Anglia Square, Norwich Transport Assessment Addendum

Transport Assessment Addendum

Anglia Square, Norwich

Iceni Projects Limited on behalf of Weston Homes Plc

DRAWN BY MG	CHECKED BY RJ	APPROVED BY CB
SCALE @ A1 1:250	DATE 08/10/2021	DATE 08/10/2021
PROJECT NO. 25-T123	DRAWING NO. 01	REV. A

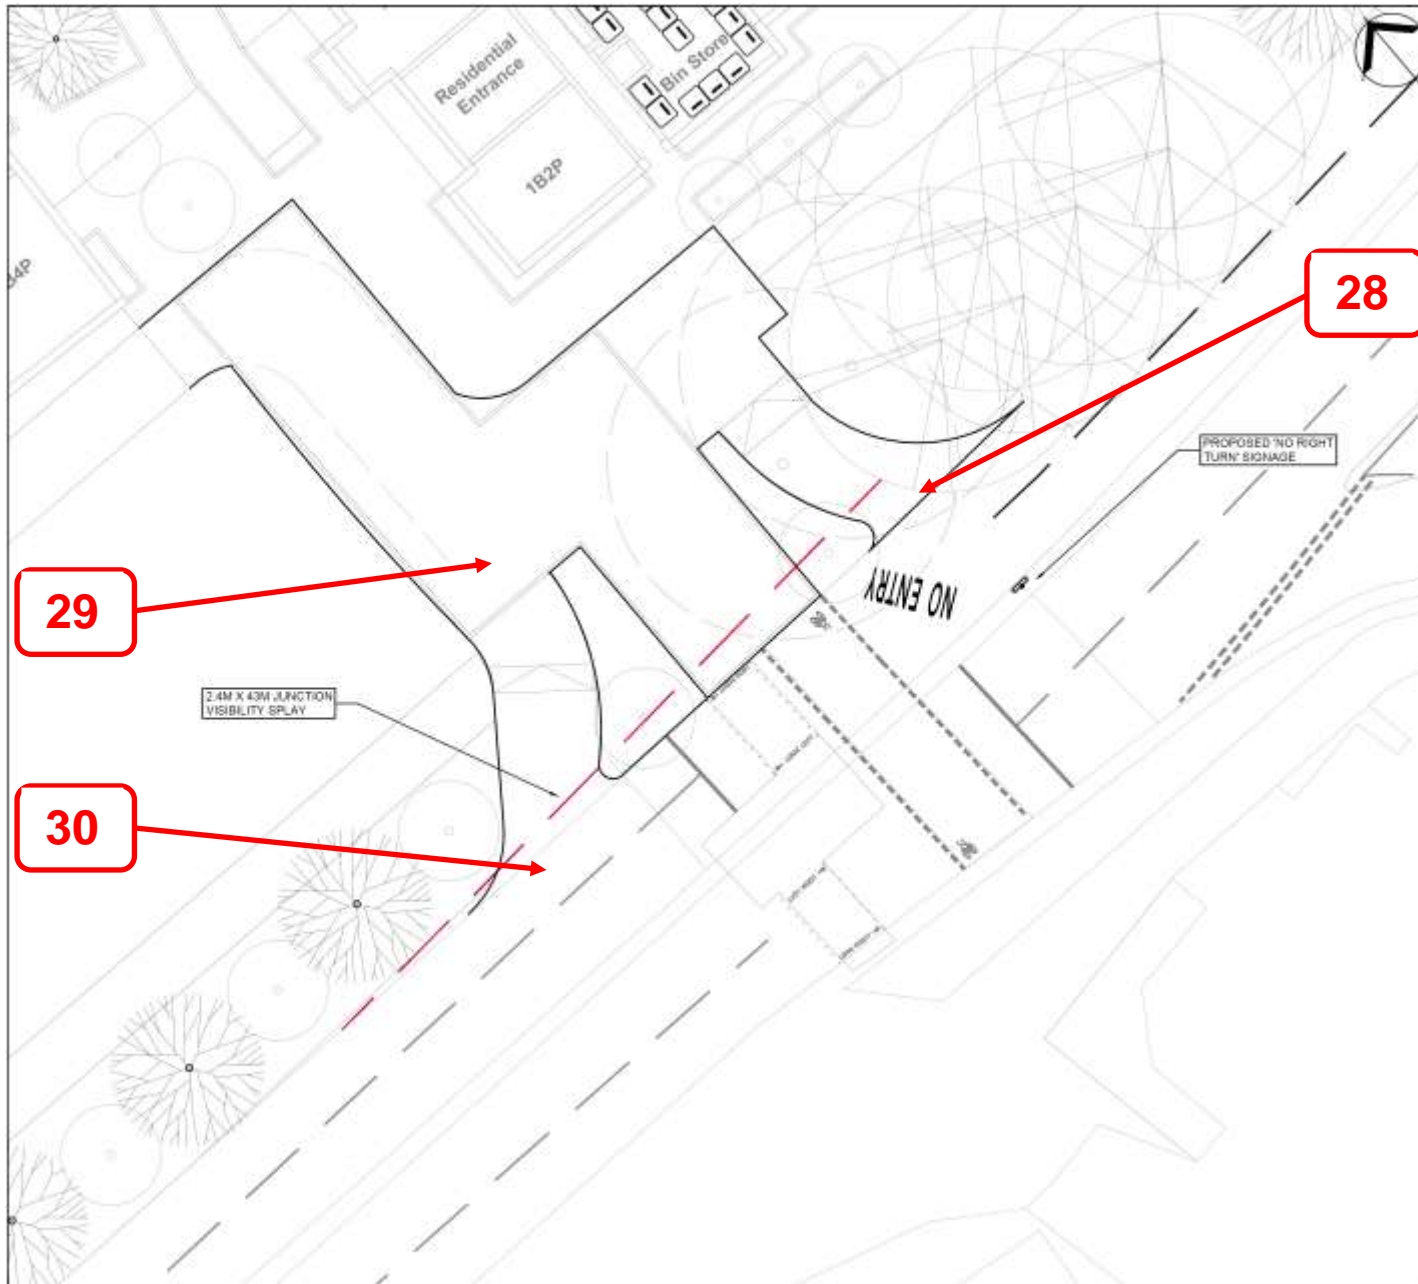
Location: 28 – St Crispins Road, proposed left out egress junction. (Drawing no. 21-T123-01 Rev A).

The scheme drawing indicates the existing diverge lane from St Crispins Road into the development site is to be removed and a left only egress provided on the eastern side of the signal controlled parallel crossing facility.

It is evident from the scheme drawing that the visibility splay would be impacted by pedestrians and pedal cyclists located on the northern side of the signal controlled parallel crossing facility when seeking to cross St Crispins Road. It would be reasonable to expect the development site would result in an increase in pedestrians and pedal cyclists using the signal controlled parallel crossing facility.

Location: 29 – Off St Crispins Road, proposed development site. (Drawing no. 21-T123-01 Rev A)

The scheme drawing indicates the existing diverge lane from St Crispins Road into the development site is to be removed and a left only egress provided on the eastern side of the signal controlled parallel crossing facility.

The site visit has established that at the end of the entry road into the development site, there is a give-way road marking, which has not been indicated on the scheme drawing.

Location: 30 – St Crispins Road, access junction. (Drawing no. 21-T123-01 Rev A)

The scheme drawing indicates the existing diverge lane from St Crispins Road into the development site is to be removed and a left only egress provided on the eastern side of the signal controlled parallel crossing facility.
